JZ24-31 THE GROVE

PLANNED REZONING OVERLAY (PRO) AGREEMENT

PLANNED REZONING OVERLAY (PRO) PLAN

DATE: 1/14/24 SCALE: HOR: 1" = 100' VER: 1" = N/A
DESIGNED BY: SRB JOB NO.: 22149
DRAWN BY: DAB SHEET: SP-3

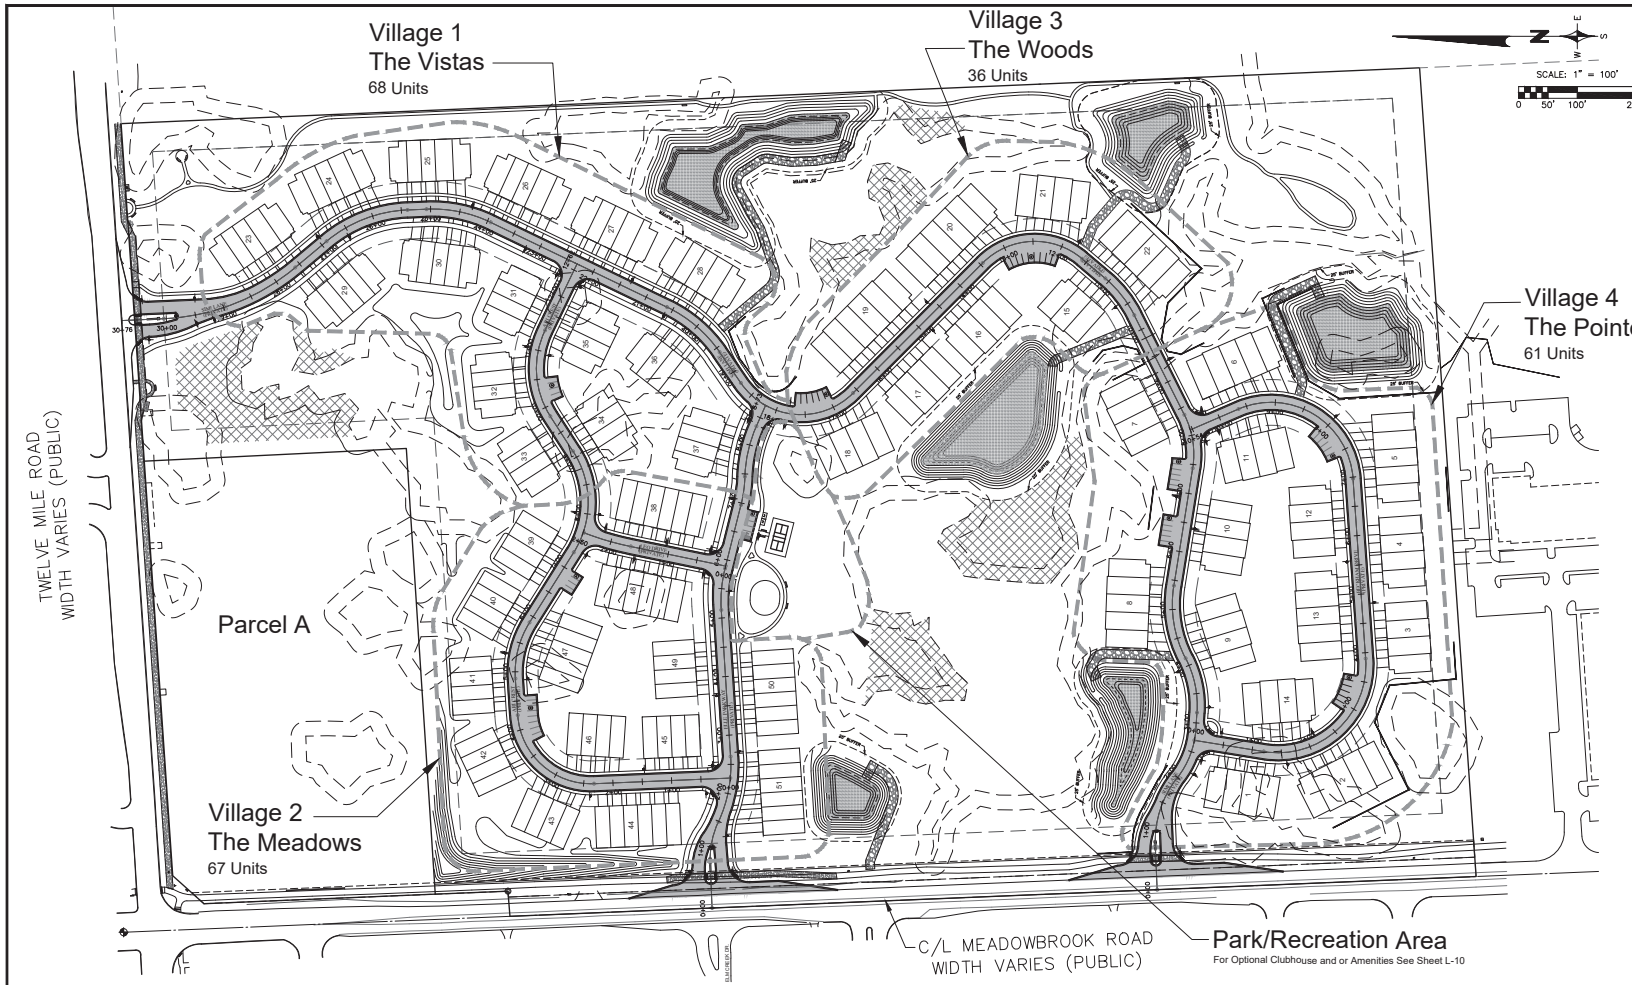
2. Sheet SP-3 indicates that decks and patios may extend a maximum of 10' beyond the building to envelope the perimeter of the building. Show deck and patios for each building to ensure there is no conflict with the detention basin drives, wetland buffers, or the retaining walls.

DATE	1/14/24	SCALE	HOR: 1" = 100'
DESIGNED BY	SRB	JOB NO.	22149
DRAWN BY	DAB	SHEET	SP-3.6

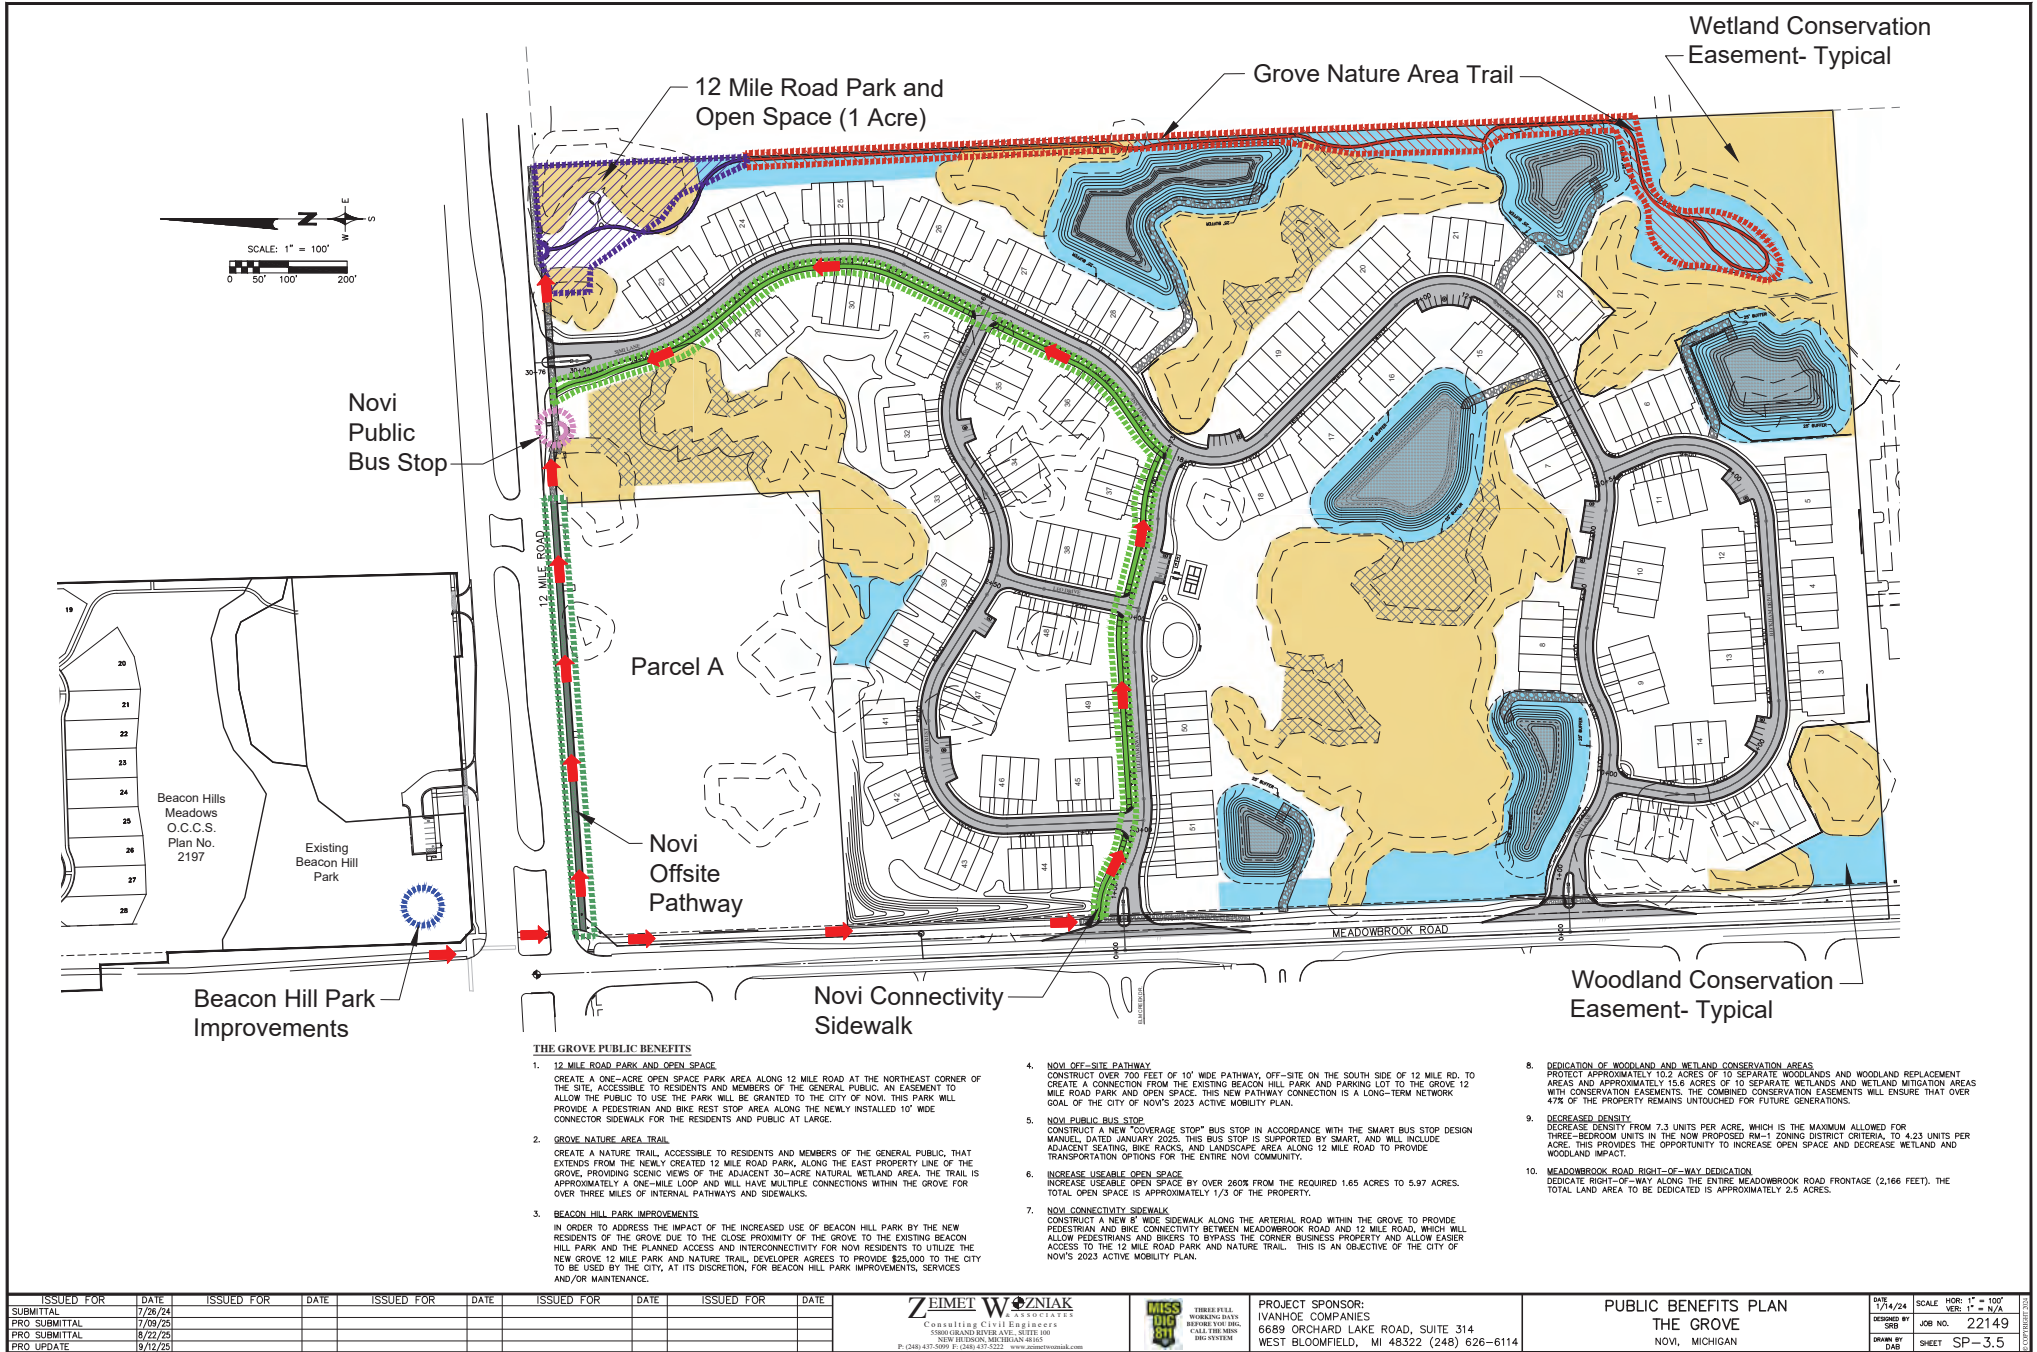
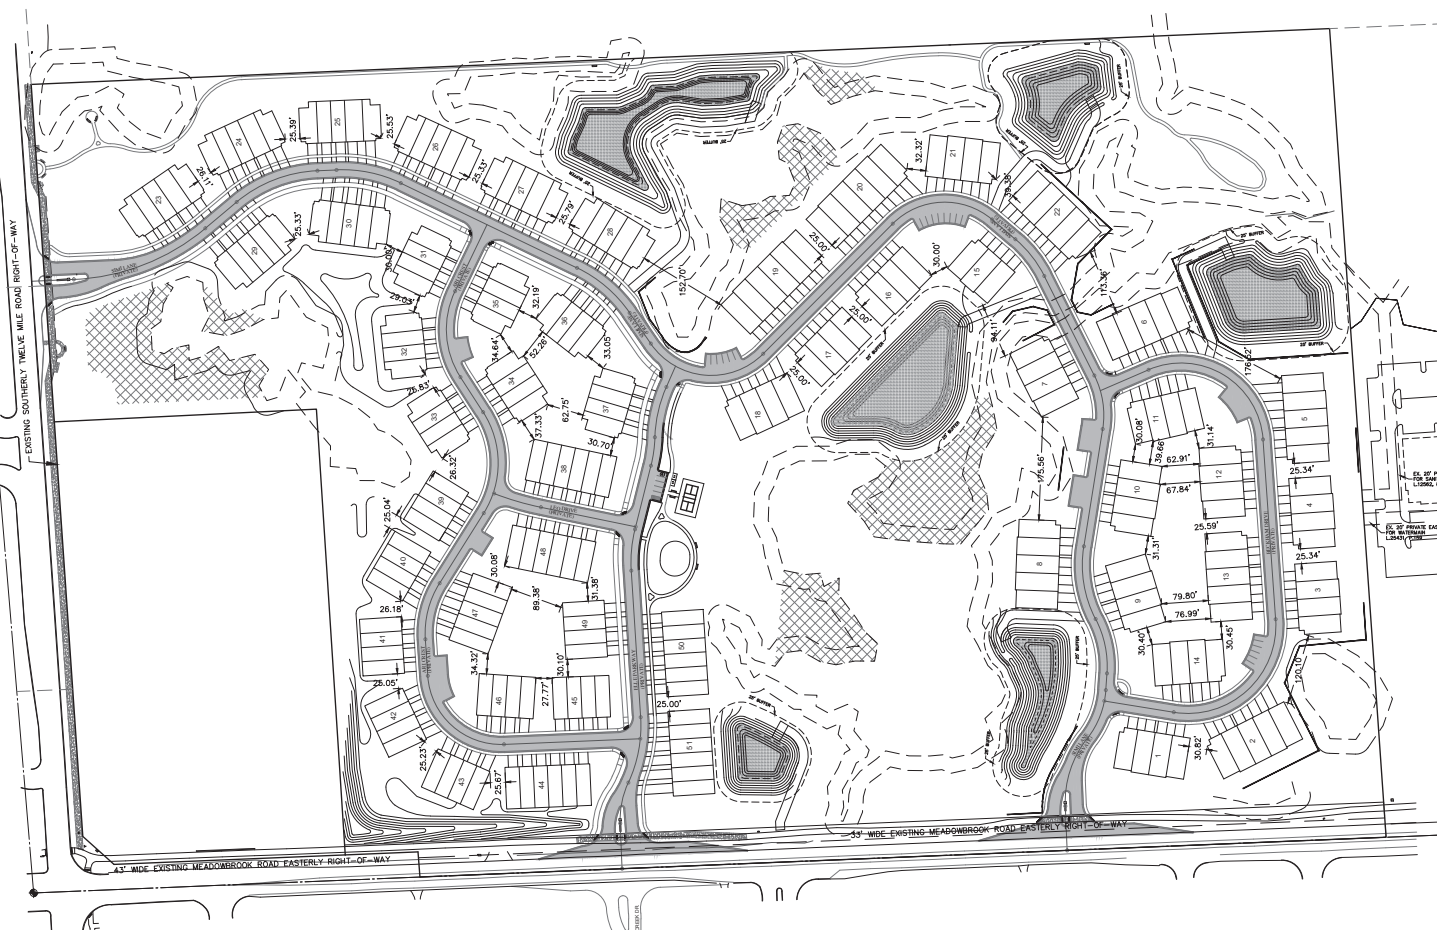
3. **Distance between Buildings (Sec 3.8.2.H):** A Zoning Ordinance deviation is requested to reduce the building separation distance from the calculated formula as shown on the Building Separation Table on Sheet SP-3.6 of the PRO Plan). **This deviation enables the layout of this project to fit within the available space while minimizing wetland and woodland impacts.**

DATE: 7/28/24 SCALE: HORIZ: 1" = 100'
JOB NO.: 22149
DRAWN BY: DAB SHEET: SP-3.8

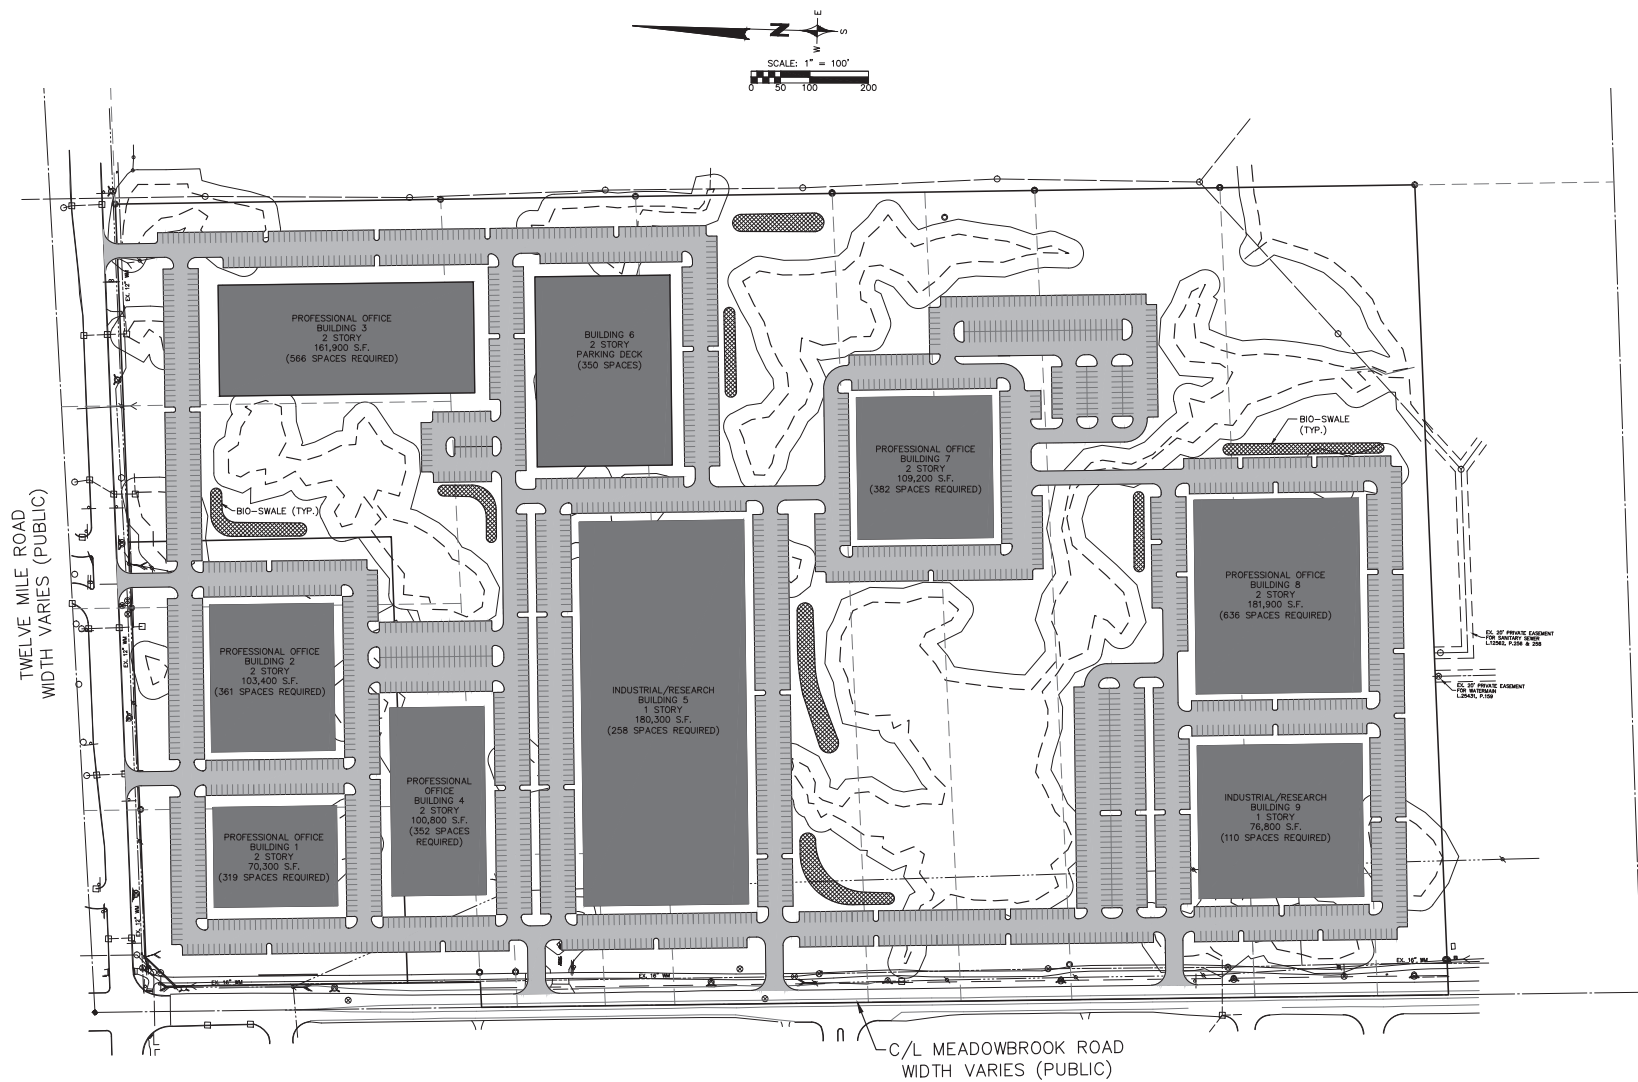
plan is provided (Sheet SP-3.8) that shows a potential OST development scenario, which includes nearly 1,000,000 square feet of building, with nearly 3,000 parking spaces. Underground stormwater detention and bioswales would be used. This parallel plan has not been fully reviewed to determine feasibility, such as accommodating wetland mitigation.
